1570 GLENMORE RD N (Municipal)

LOT 2, PLAN 4223, SEC 16, TP 23 (Legal)

MEMORANDUM

Date: August 11 2015
File No.: Z15-0037
To: Land Use Management Department (PMcV)
From: Development Engineering Manager
Subject: 1570 Glenmore Rd N Lot 2 Plan 4223

SITE PLAN

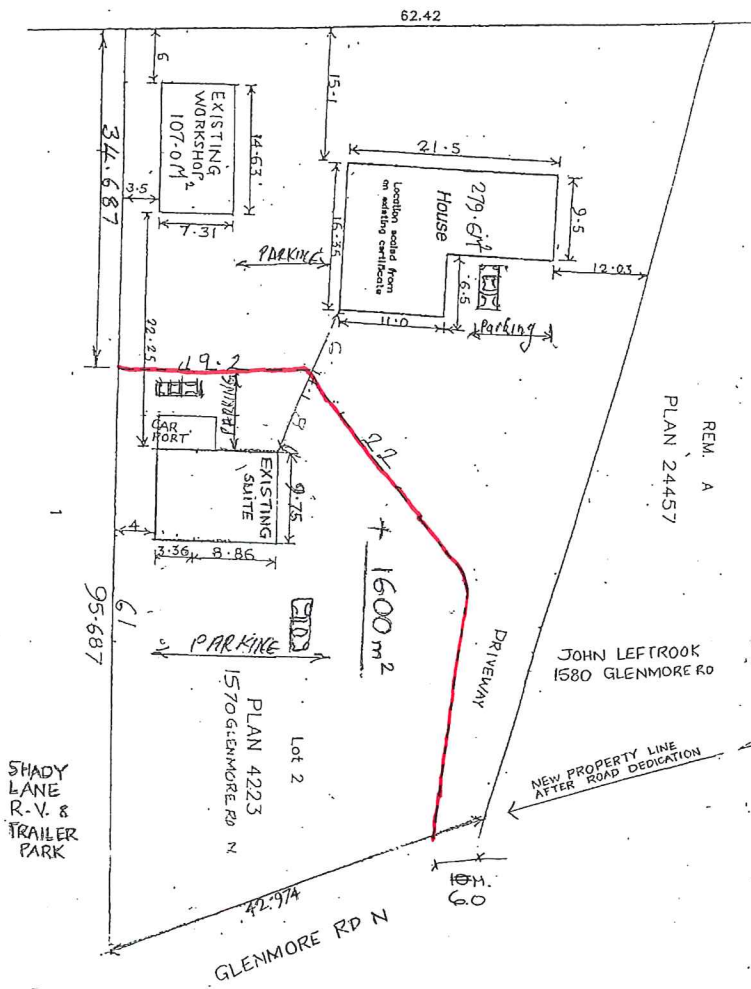
- a) A requirement of this rezoning application will be to prepare a storm water management plan complete with a detailed Site Grading Plan including erosion and sedimentation controls required onsite and on the frontage road.
- b) Show details of dedications, rights-of-way, setbacks and non-disturbance areas on the lot Grading Plan.

- a) A cross access agreement is required which will facilitate a future common Glenmore Rd access. Vehicles from the subject property will access through the adjacent land (Lot 2 Plan 4223) to the John Hindle Drive intersection. At present, access to the subject property is very close to the intersection resulting in intersection safety concerns. This issue will only be amplified as future development occurs. This agreement need only cover the obligation of the current application, but the driveway must be configured to permit the future common driveways to operate.
- b) Ultimately the west leg of the John Hindle Dr and Glenmore intersection will need to be realigned with the east leg and the split phasing removed.
